Application No. 10/568,800
Supplemental Amendment dated June 12, 2009
Reply to Office Action of March 9, 2009

Docket No.: 66967-0008

REMARKS

Fig. 3b

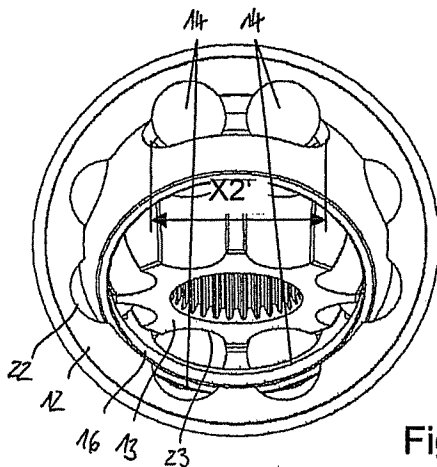
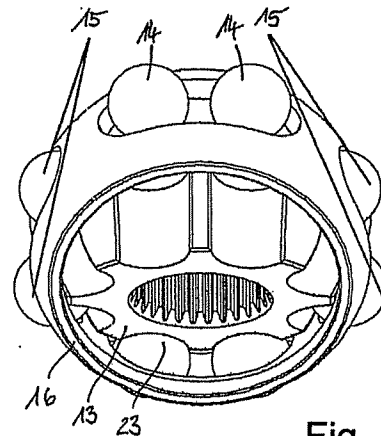
As an initial matter, the *Ouchi* reference fails to teach a twin ball joint, as expressly claimed by Applicants in claim 5. Indeed, Applicant's invention, as defined by independent claim 5, is "a constant velocity twin ball joint comprising: ... circumferentially adjoining pairs of tracks compris[ing] center lines of the outer and inner ball tracks which, when the first and second axes are aligned, are positioned in planes which extend parallel relative to one another and are symmetric relative to the first and second axes." As seen in FIGs. 3b or 3d below, a web is positioned between the balls 14 has a constant width over its length, thereby keeping the respective ball tracks parallel to each other.

Further, there are several limitations in claim 5 that are simply not present in *Ouchi*. In the Office Action, the Examiner specifically refers to the embodiment of FIGS. 10 and 11 of *Ouchi* to teach certain limitations. However, the embodiment of FIGS. 10 and 11 illustrate that the cage comprises first cage windows 310e with a longer length in which there are held three balls 304, and shorter cage windows 310d in which there are held two balls. Thus, *Ouchi* fails to teach “a ball cage between the outer joint part and the inner joint part and comprising circumferentially distributed cage windows which each cage window accommodates a pair of balls” as expressly claimed by Applicant’s independent claim 5. Therefore, for at least this separate reason Applicants’ independent claim 5 is not anticipated by *Ouchi*.

In the Office Action, the Examiner also specifically refers to two *varying* embodiments of FIGS. 12A and 12B of *Ouchi* to teach certain other limitations. Indeed, as stated in paragraph [0094] of *Ouchi*, FIG. 12A shows “a preferable working” and FIG. 12B shows an “unpreferable working.” However, as seen in FIGS. 12A and 12B, the windows (310e, 310d) disclosed in each separate embodiment have the same circumferential length. Thus, the ball cages of *Ouchi*, shown in Figures 12A, 12B, both fail to teach, disclose or even suggest, “wherein a circumferential length of second cage windows for second pairs of balls is smaller than a circumferential length of first cage windows for first pairs of balls” as claimed by Applicant’s independent claim 5. Therefore, for at least this separate reason Applicant’s independent claim 5 is not anticipated by *Ouchi*.

The embodiments of FIGS. 12A and 12B also teach away from claim 5 in that paragraph [0184] expressly teaches that the two inside surfaces of the cage pockets 310d, 310e shall not be parallel to one another. In contrast to this express teaching, claim 5 requires that the pairs of ball tracks are arranged in parallel planes. Thus, the side faces of the cage also need to be in parallel planes. For this separate reason, claim 5 is patentable over *Ouchi*.
